From: Tom Darwall Smith <Tom@maddoxassociates.co.uk>
Sent: 26 May 2016 20:51
To: Haji-Ismail, Zenab; Minty, Stuart; Powell, Antonia
Cc: David Maddox; Alasdair Buckle
Subject: Fw: 2016/1590/P- Abacus Belsize Primary School - Additional information and response to HCRD objection
Attachments: 114031-P009 - Existing External South East Elevation.pdf; 114031-P504 - Proposed External South East Elevation.pdf; 114031-P700 rev 1 Proposed 3D Visuals.pdf; 114031-P800 - Proposed Internal Corridor Treatment.pdf; 114031-P801 - Proposed Access Diagram.pdf; 160526 HCRD Objection response table.pdf

PROJECT
 Abacus Belsize Primary School
 26a Rosslyn Hill, London NW3

2016/1590/P Abacus Belsize Primary School
 Applicant response to report dated 29 April 2016 commissioned by Hampstead
 Community for Responsible Development (HCRD)

DRAWING NAME
Proposed Internal Corridor Treatment

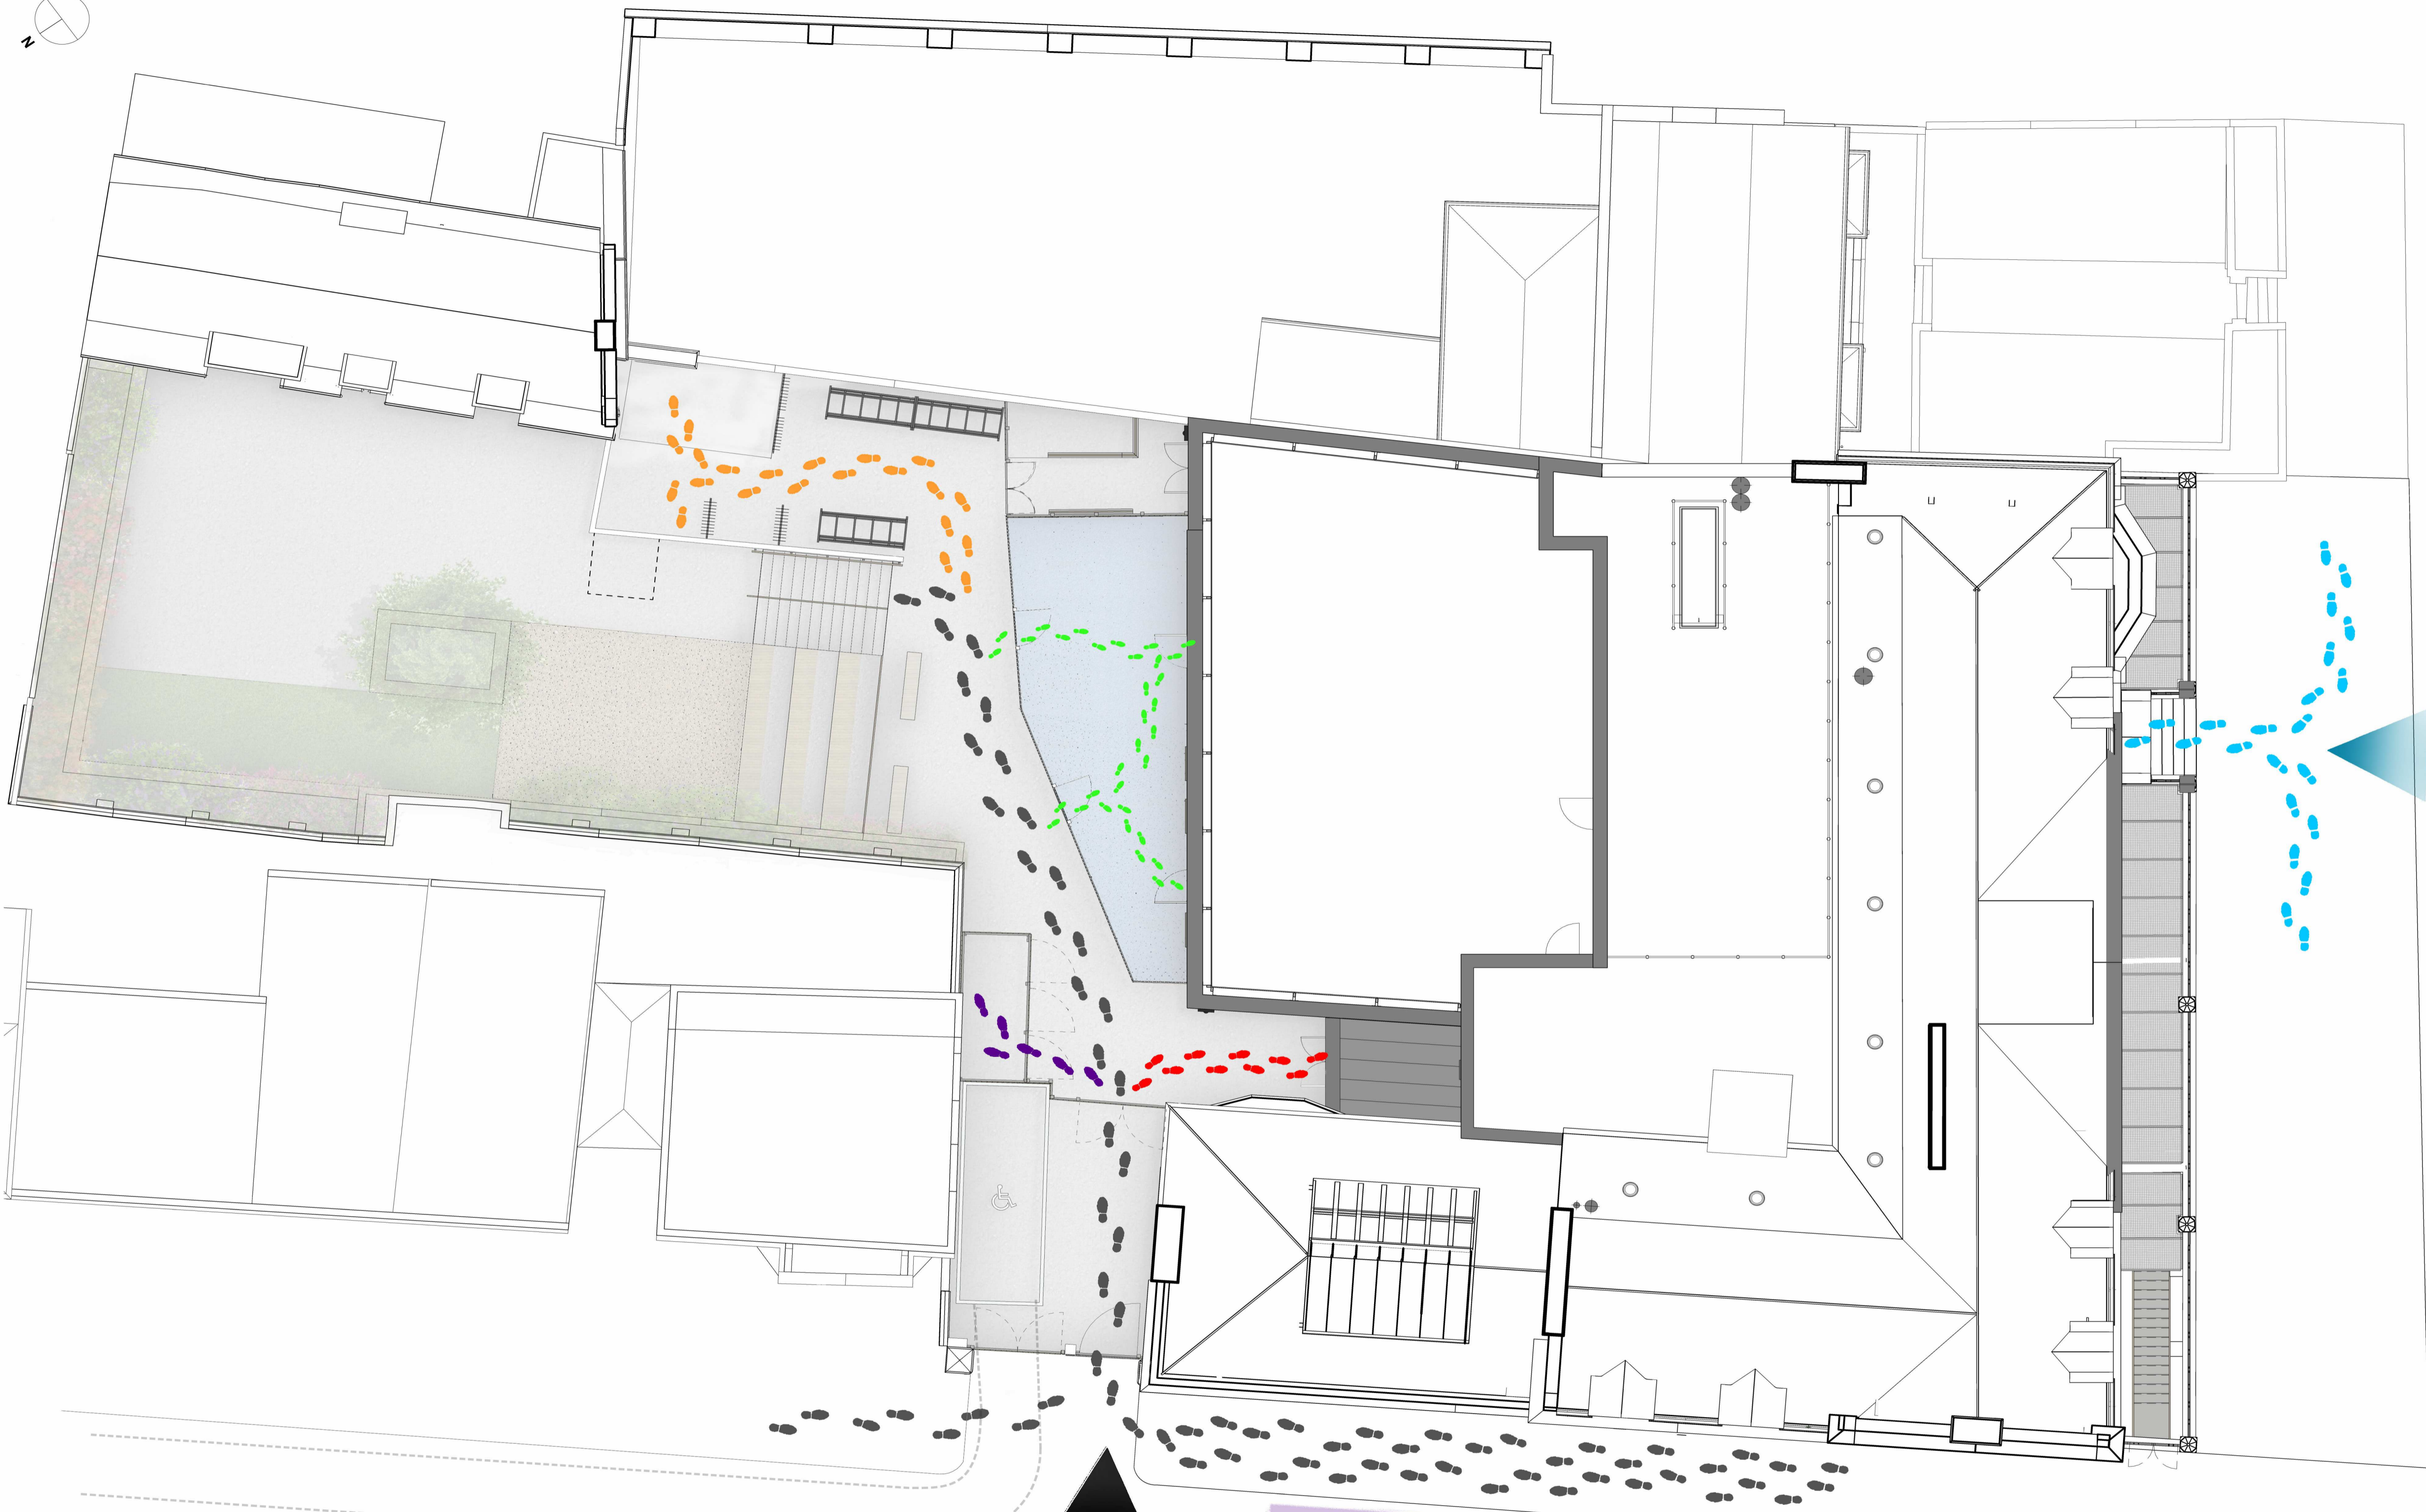
Objection	Response
5.12- Bullet 3. The scheme proposes the replacement of the rear cell wing with a much larger new wing. No certainty is given over whether the rear wall will be retained.	The existing rear wing is of reduced value due to its utilitarian nature, history of extensive alteration, and the unsightly brick and metal additions to the exterior. The new rear wing would be wider than the existing one, but of a similar height, and its exterior character would be much more coherent. The rear wall of the Rosslyn Hill block will be retained in the new scheme, and will be restored to act as a main feature within the circulation space.
Objection	Response

Windows which stagger the floor level to the new corridor will be retained at high level for heritage benefits and to provide some borrowed light to the corridor. These staggered windows mark the previous location of the staircase.

Boxing around internal RWP, matched to the existing position of RWPs where possible. The boxing will effectively frame the existing brickwork to enhance it as a feature of the corridor.

Existing windows retained where possible within the exposed brickwork wall.

The existing external wall of the listed building is to be exposed in the corridor of the school, subject to its condition.

Windows which stagger the floor level to the new corridor will be boarded at low level to mitigate the risk or damage to the window. The original window frame and glazing will be retained behind the boarding.

New 150mm skirting to protect the exposed brickwork at low level.

Proposed Access Diagram

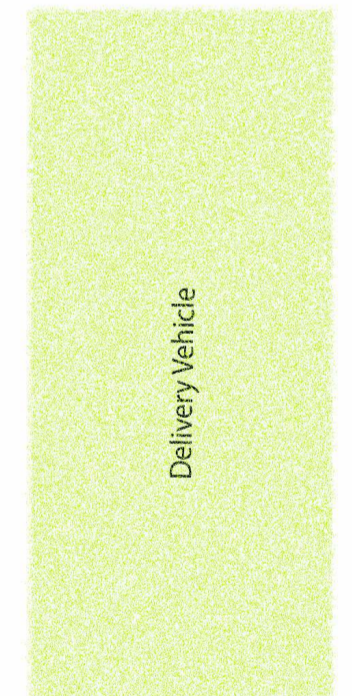
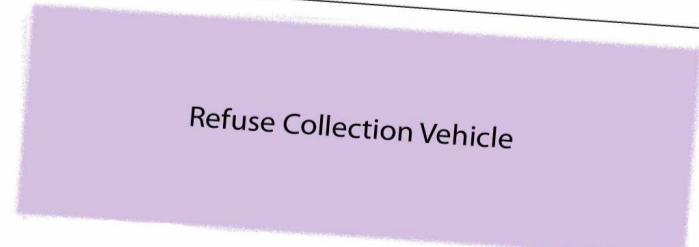
Objection	Response
4.13 b)- Bullet 1. No swept path analysis for refuse vehicle access has taken place to accommodate such large vehicles.	The servicing of the site has been discussed with Camden who agrees that as with the current practice in Downshire Hill the collection/delivered can wait at the entrance on the basis of pauses/load/proceed.
Objection	Response

4.13 d)- Bullet 2. There may be potential safety conflicts around the school entrance if a parent/visitor is trying to use the disabled parking space during peak hours, as it is obscured from the road and pedestrians may be in the way.	Access to the disabled parking bay will be managed as and when required by the school. The school fully recognises the need to manage its transport affairs at all times.
Objection	Response

Objection	Response
<p>6.38-6.41 ("<u>accessibility</u>"). The main entrance should be on Rosslyn Hill. The conflict of use between the Downshire Hill entrance, acting as a service area, disabled car park and entranceway is unacceptable in safety terms. 800 pupils and parents (200 on Rosslyn Hill and 600 on Downshire Hill) will congregate in the mornings and afternoons, which will create unacceptable pedestrian issues.</p>	<p>The stated visitor numbers are over-inflated and unsubstantiated. The reality will be significantly lower, given:</p> <ol style="list-style-type: none"> 1. the high level of encouragement towards "pooling" school walks among parents in the School Travel Plan; 2. that the HCRD statement takes no account of staggered arrivals and departures; 3. that the school currently runs an early drop off facility (five days a week); 4. that the school anticipates expanding a breakfast club at the proposed site. Based on current attendance, breakfast club take-up is anticipated at around 15%; 5. that the school currently runs after school clubs (three per night five days per week). This would continue at the proposed site estimated 30-45% of pupils will attend until 4pm (one hour after school end, at 3pm); 6. that the school will also seek to provide additional care for around 10-20% until 6pm. <p>Downshire Hill is not expected to be an area where parent congregate since parents will be able to enter the site to collect children, rather than wait outside the school gate. Drop-offs/collections at the Rosslyn Hill entrance will further reduce any pressure in the area.</p>
